Access Compliance Report

Public Rights-of-Way

(Curb Ramps)

Intersection ID: 50516	Main Street: MICHAEL_CROSSING_DR	Cross Street: MCLEAN_RD	Location: E
ADA ID: F2ED174F157F	Ramp Type: Combination2	Initial Pass/Fail: Fail	Overall Compliance: No
Severity Score: 13.75			
Codes/Mitigation Info/Possible Solution		Field Measurements/Component Compliance

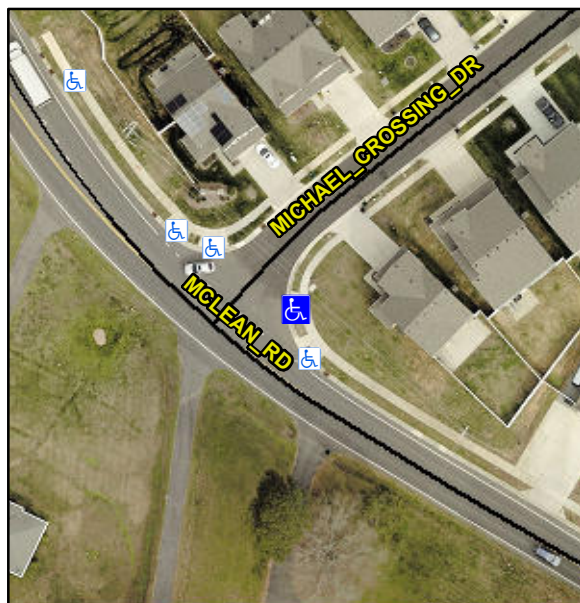
RT RP < 5%

Not Found, R304.5.3, R304.3.2

Remove & Replace Entire Ramp.
